**Stratham Planning Board
AGENDA
July 13, 2022
Stratham Municipal Center
Hutton Room
Time: 7:00 PM**

- a. Tulip Tree, LLC (Owner), Kyle & Sophie Saltonstall (Applicants) - Request for approval of a site plan amendment to allow for modifications to the landscape plan associated with an event venue, non-profit lodge, and private school use at 61 Stratham Heights Road (Tax Map 5, Lot 81) approved by the Planning Board on March 6, 2019, Zoned Residential Agricultural.
- b. To amend Section 4.2.7 of the Site Plan Regulations for the purposes of adding application fees for applications submitted under the Route 33 Neighborhood Heritage District.

TO: Planning Board Members
FROM: Mark Connors, Town Planner
FOR: July 13, 2022
RE: **Site Plan Amendment application, 61 Stratham Heights Road**

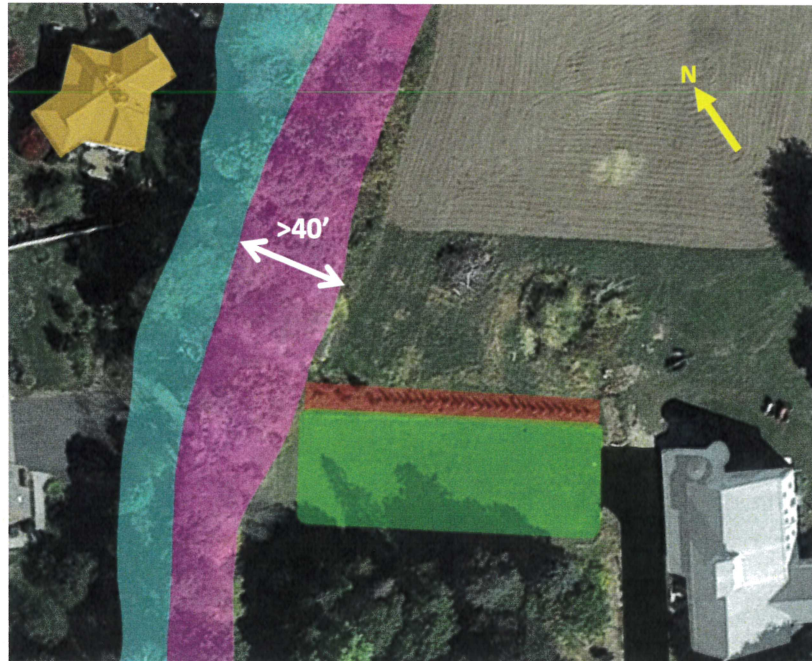
I am writing to ask for an amendment to our current site plan for our property at 61 Stratham Heights Road. The site plan originally called for evergreen trees (highlighted in red) to be planted on the north side of our eco-parking area (highlighted in green).

The original intent behind placing evergreen trees along the north side of the eco-parking area was to shield the Cooper residence (highlighted in orange) from nuisance noise and light emitted from usage of our eco-parking area. Stratham's Site Plan Review Regulations Section 5.2-C-2 states that "Landscaping... must be provided with proper regard to adjacent properties... *including interior landscaping of parking areas.*" Because of this, the more than 40' of dense vegetation (highlighted in pink and blue) between properties was deemed inadequate and we added landscaping around our eco-parking area.

Seeing as we are currently working on a superior plan with long term durability – yet are still very interested in meeting the intent of the original site plan in the meantime – we are asking for the approval of the Planning Board to amend the site plan to allow us to continue maintaining the area in question using a more “farm-ish” practice. The area immediately north of our eco-parking area is currently growing eight closely spaced rows of sweet corn. The plants are well on track to meet the adage of “knee-high by the Fourth of July,” and are well fertilized and well irrigated. Anyone who has visited the Scamman Farm’s corn maze knows how effective a corn wall can be at screening sound and light, and we have planted the area far thicker than the walls in the Scamman Farm corn maze. We expect that our corn will be well over head height by the time that our season gets busy in September and October.

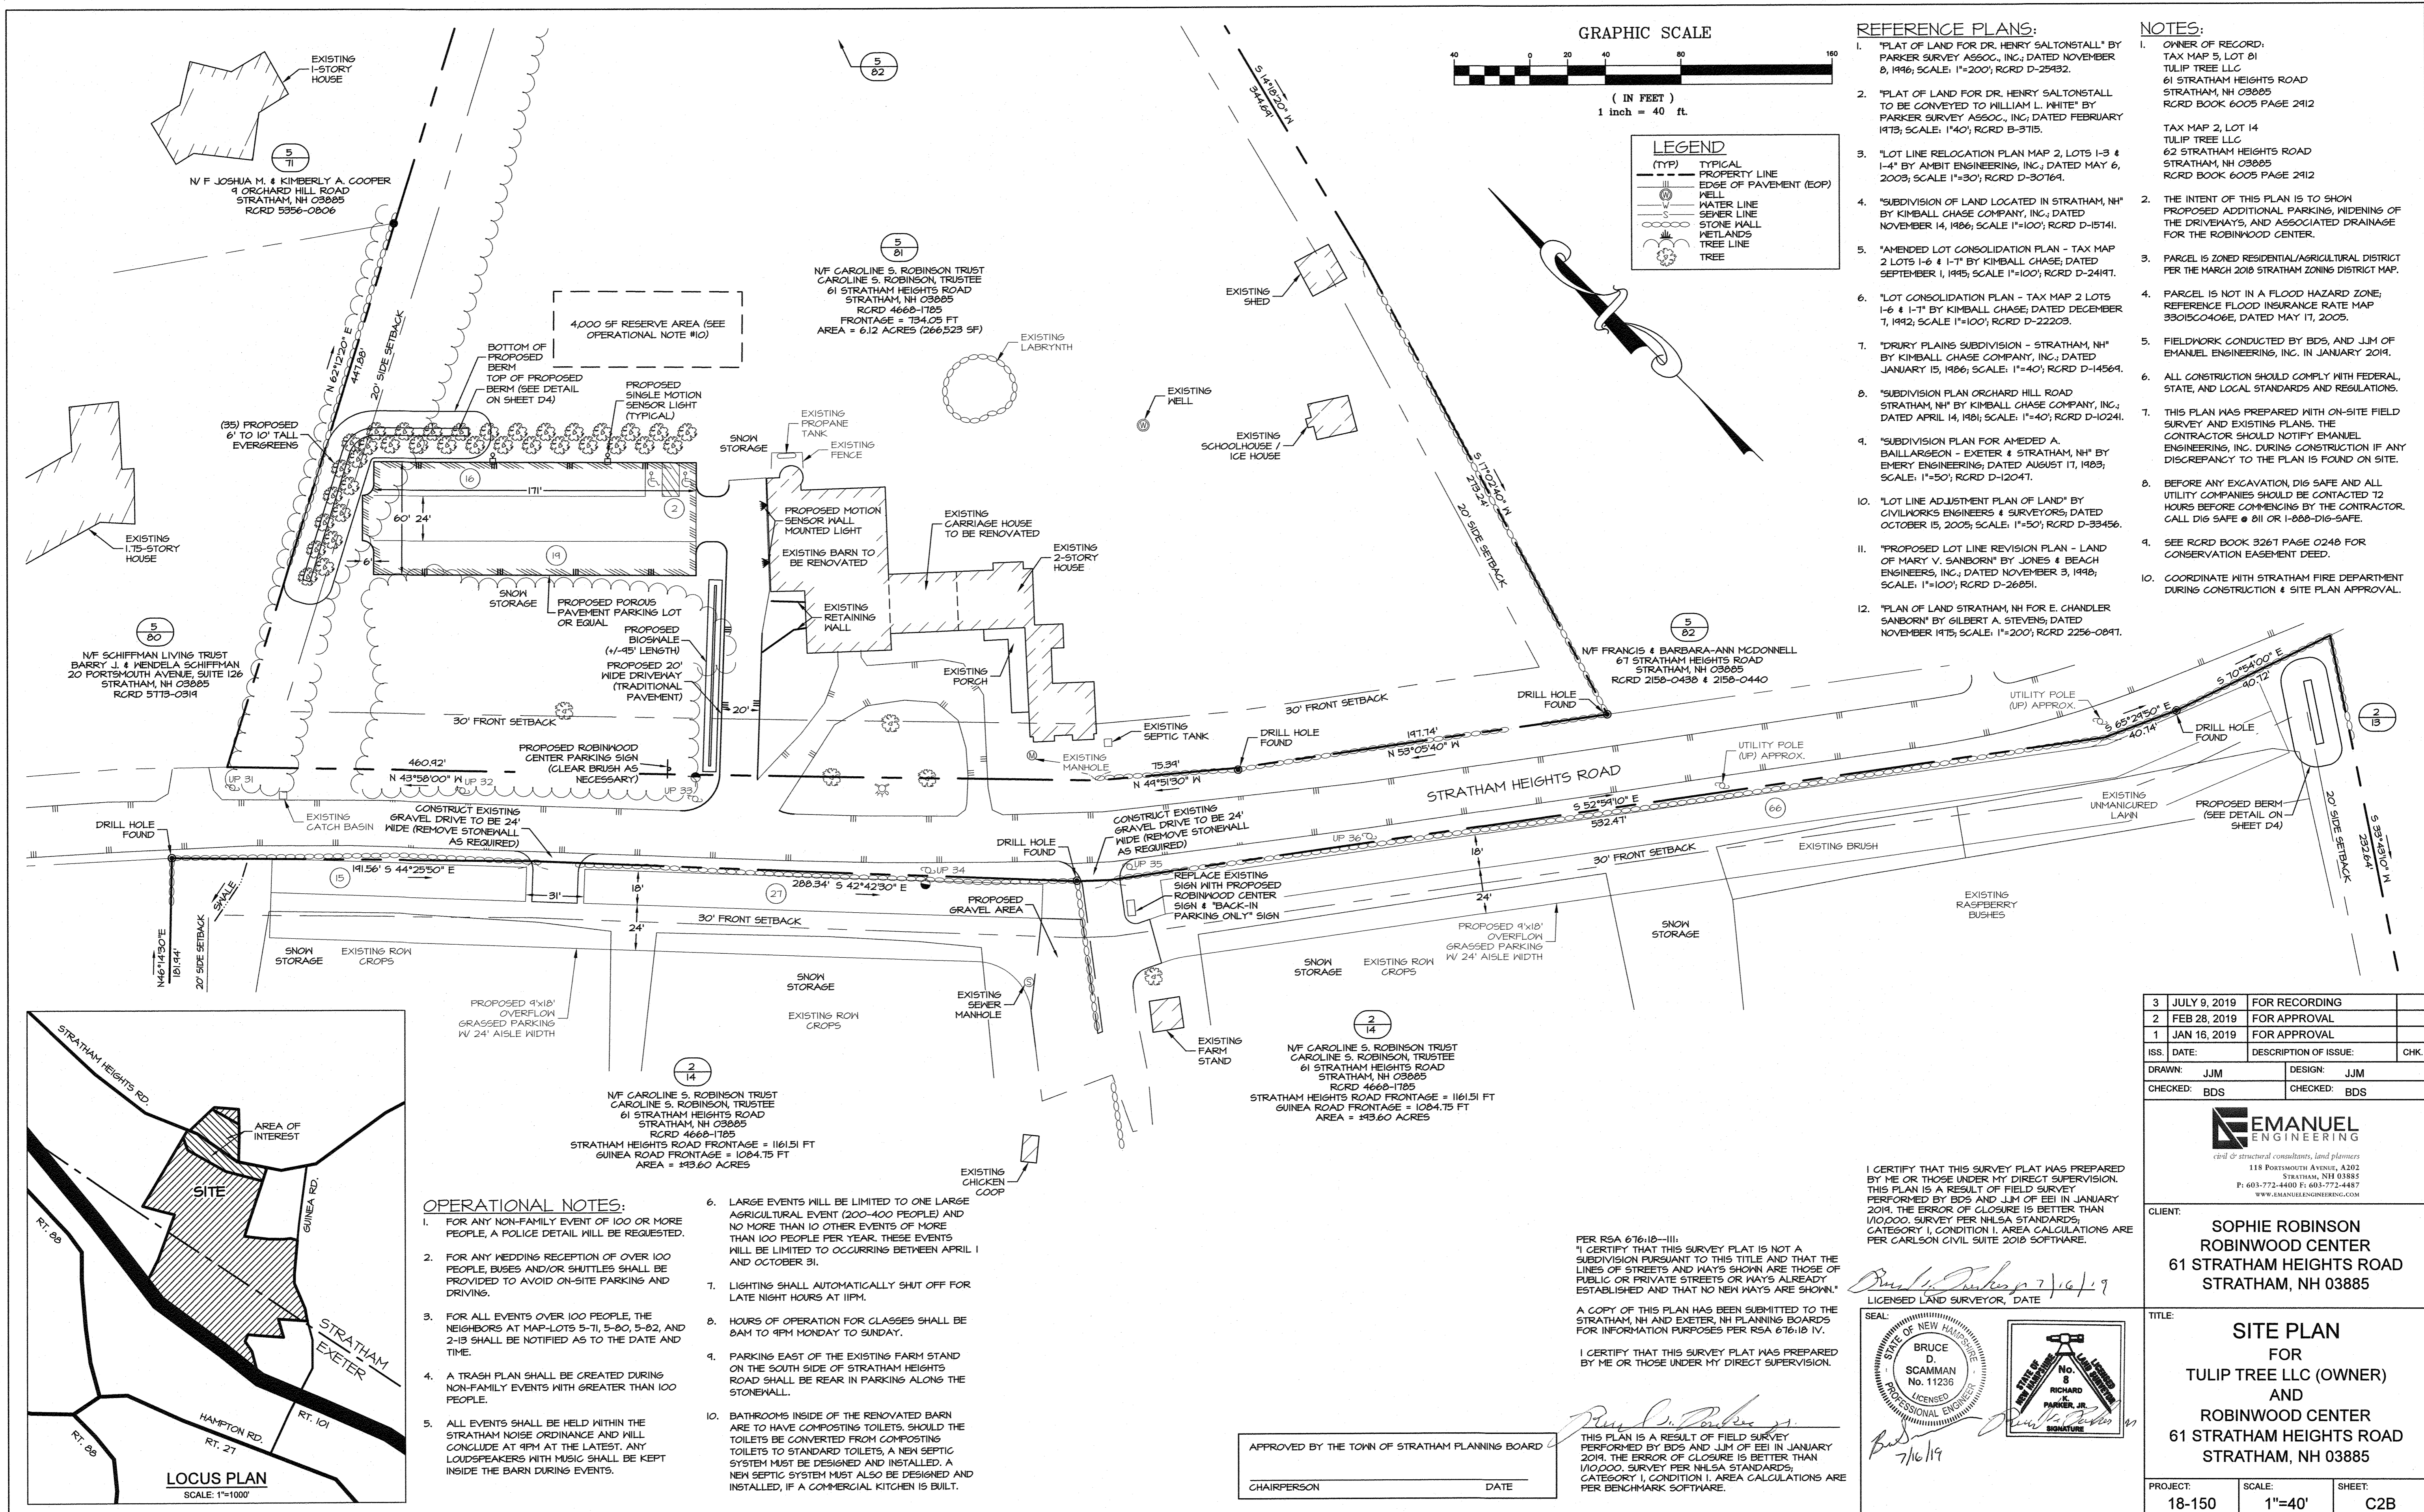
The site plan that the Planning Board approved included a row of 35 arborvitae trees adjacent to one of the parking areas. Although at one point the landscaping was installed, it appears many of the trees died and no longer exist.

The applicants are requesting that the landscaping in question be replaced, as a short-term measure, with eight rows of sweet corn that they have already planted. The Saltonstalls have not provided a plan or photographs of the corn so it is difficult to visualize what they are proposing, however staff will attempt to visit the site to take photos in advance of the Planning Board meeting. The applicants have indicated that they are working with engineers and landscape architects to develop a more comprehensive site management and landscape plan “that will far exceed the intent of the

Staff does not believe corn is a reasonable alternative to the more comprehensive landscaping that was included in the approved site plan. It is important to note that the Town did not develop the landscaping plan; the applicants developed the plan likely with some input from abutting property owners. The Town is merely enforcing the approved site plan the applicants developed. The Town would welcome the opportunity to review a revised landscape plan, but the applicants have not provided one, only the promise to submit one at a later unspecified date. It could be years before one is submitted. It has been nearly five months since the Town first formally notified the applicants of this compliance issue. Staff believes that should have provided sufficient time for the applicants to develop and provide the Town a revised plan.

New Hampshire provides a good climate for a wide diversity of landscaping provided adequate site preparation is made, irrigation is installed, and that the plantings are maintained. The applicants have not provided any technical exhibits to indicate why the land is not appropriate for landscaping.

Because the applicants have not provided a viable revised plan, staff would recommend that the Board deny the request for an amendment to the plan and uphold the original site plan but provide the applicants a 60-day window in which to make the improvements. However, staff would recommend that the Board provide the applicants some additional flexibility and allow for some minor revisions to the landscaping plan at the discretion of the Town Planner if a certified professional develops an alternative plan that meets the intent of the original landscape plan (see language of Condition #1).

I move that the Planning Board deny the request for a site plan amendment because the request is not in conformance with Section 5.2 of the Stratham Site Plan Regulations. Further, the Planning Board directs the Code Enforcement Officer to enforce the approved 2019 Site Plan for 61 Stratham Heights Road, but to withhold enforcement action for a period of 60 days to allow the applicants the opportunity to bring the property in compliance. This decision is subject to the following condition:

1.) The Town Planner may approve minor revisions to the approved landscape plan, at his discretion, if a certified professional provides written justification for the revisions and if the revised plan is consistent with the purpose and intent of the approved landscape plan.
